**LIMITED ARTIFICIAL AND NATURAL ICING TESTS
PRODUCTION UH-60A HELICOPTER
(RE-EVALUATION)**

FINAL REPORT

SUBJECT: Directorate for Development and Qualification Position on the Report of USAAEFA Project No. 80-14, Limited Artificial and Natural Icing Tests, Production UH-60A Helicopter (Re-evaluation)

Photo 2. Cracked Copilot's Windshield

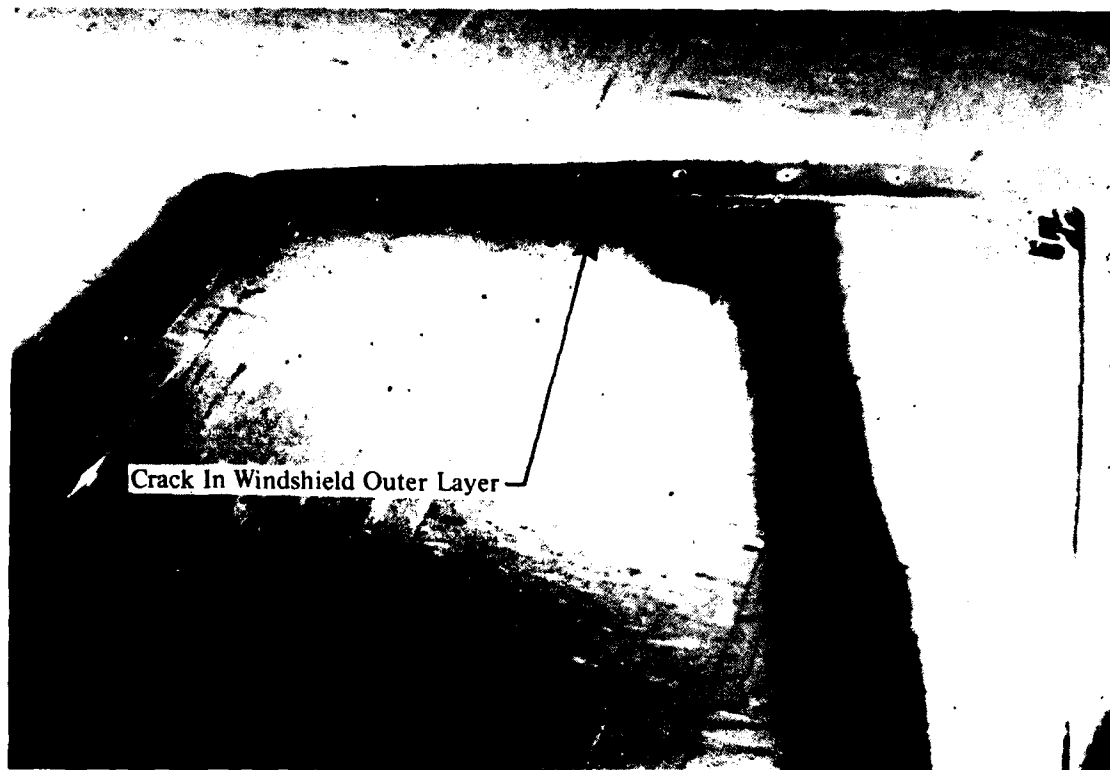
be extremely hot and one-third extremely cold. Thermal stresses resulting from these failures caused the cracked windshield (photo 2, app G) during this test. The poor reliability of the windshield anti-ice control units is a shortcoming. The following caution should be placed in the operator's manual as soon as practicable:

Continued use of a faulty windshield anti-ice system may result in structural damage (delamination and/or cracking) to the windshield.

Photo 11. Ice Impact Damage to Nose Avionics Compartment Door

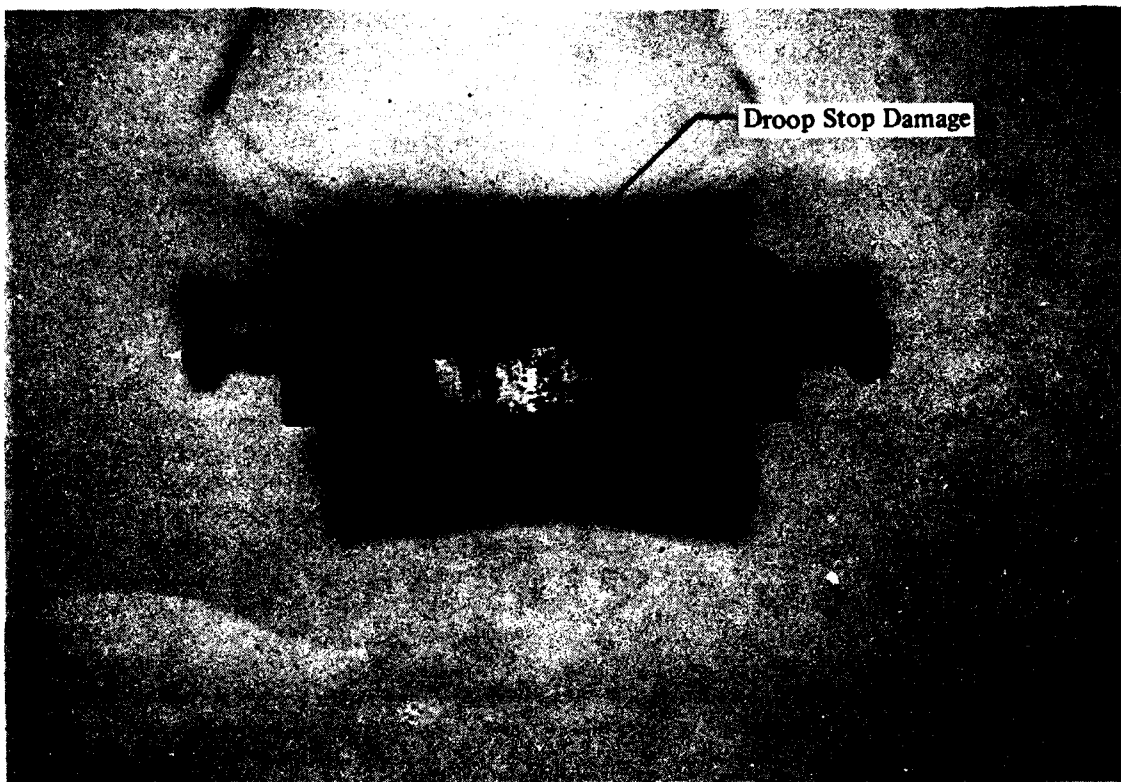
18. As previously reported, all inflight data indicated clean shedding of the heated portions of the main rotor blades during the deice cycles. Photographic confirmation of this fact was possible throughout the artificial tests. In natural icing conditions, with the collective fixed, the engine torque rise associated with rotor system ice accretion was completely eliminated at the completion of a deice system cycle (para 21). During icing encounters (natural and artificial) the crew detected fuselage impact with shed ice particles, principally by sound (thump on fuselage) and by visual means under some lighting conditions (artificial conditions only). Most frequently, ice was shed as the advancing rotor blade approached the aircraft three o'clock position. The trajectory of the shed ice particles caused numerous fuselage impacts which could sometimes be heard in the cockpit. Following each icing encounter additional dents (photo 11, app G) were noted on the nose avionics compartment door. The ice impact damage to the nose avionics compartment door is a shortcoming.

k. Paragraph 35b: The impact damage for ice on the nose avionics compartment door is not considered a shortcoming in that it was minor and resulted in no malfunction or other measurable degradation of aircraft operation. Some impact damage is always inherent with a de-icing system.

Photo 12. Broken Upper Strobe Light Assembly

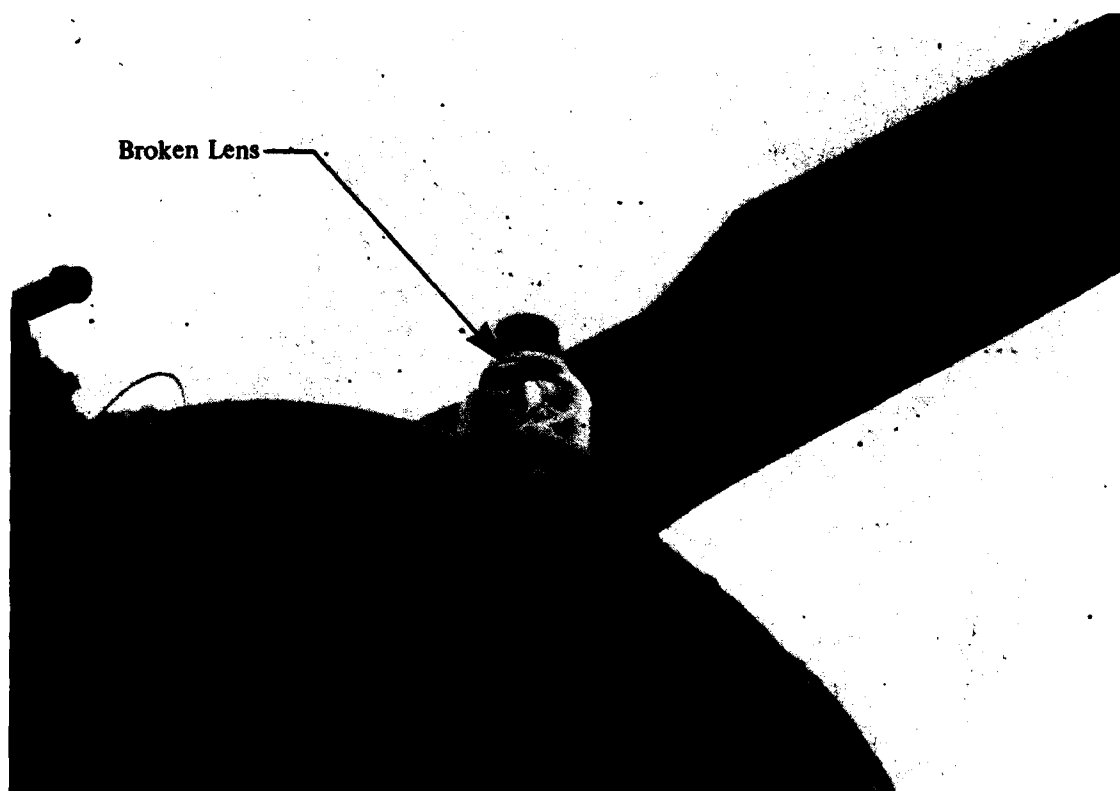
19. Additionally, two instances of ice particle impact damage to the upper strobe assembly (photo 12, app G) were documented. One upper strobe assembly sustained sufficient damage to shatter both the red and white lens components which then struck a tail rotor blade producing the damage shown in photo 13. Ice impact damage to the upper strobe assembly is a shortcoming. As a result of rotor blade ice shedding characteristics the following note should be placed in the operator's manual prior to release of the aircraft for flight in an icing environment:

- a. Ice impact damage to the upper strobe light assembly (para 19)
- b. Ice impact damage to the nose avionics compartment door (para 18)
- c. The poor reliability of the windshield anti-ice control units (para 14).

j. Paragraph 35a: An investigation will be held to determine if design criteria for the strobe light assembly adequately contains criteria for impact damage from ice, rocks, etc. Improved criteria for this type problem will be stressed in future strobe light designs.

Photo 15. Broken Main Rotor Distributor Wire Attachment Clamp

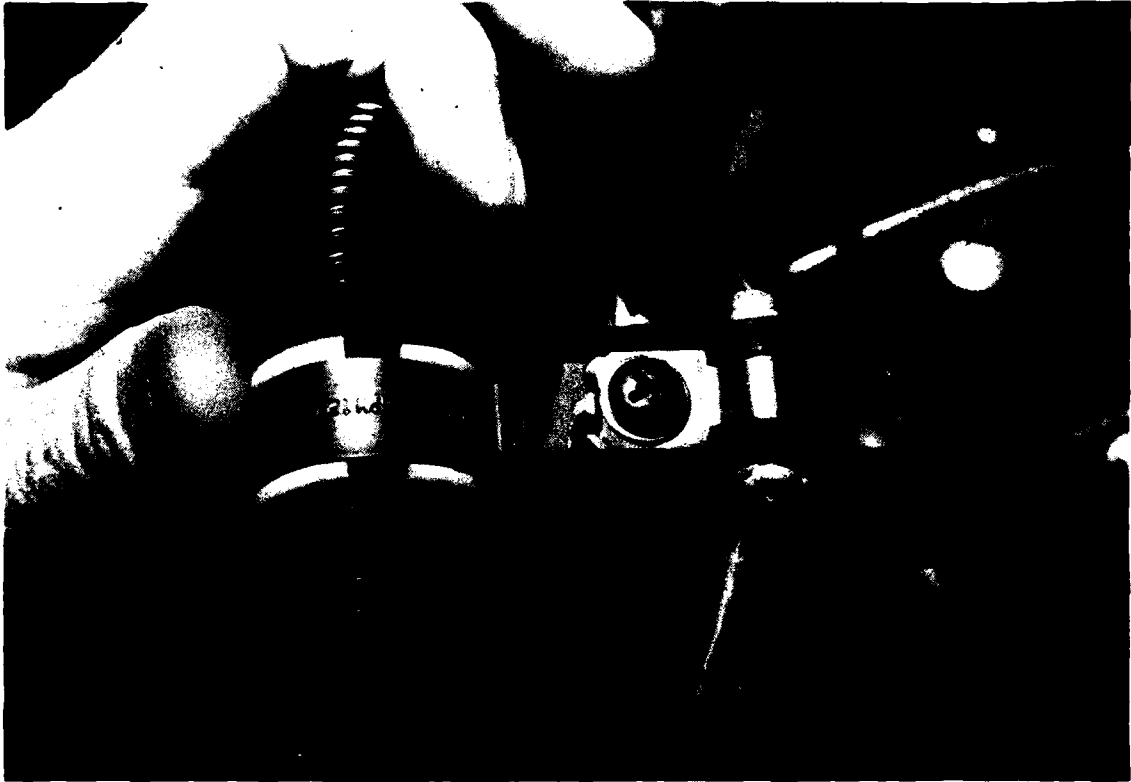
25. During previous testing and the initial weeks of this year's program, multiple failures of main rotor distributor wiring clamps (photo 15, app G) were observed. After the incorporation of Sikorsky Aircraft Division Engineering Order No. 90790, drawing number 70070-55003 (photo 16, app G), no subsequent failure of these devices were experienced. Within the scope of these tests, the reliability of the improved main rotor distributor wiring clamps was satisfactory.
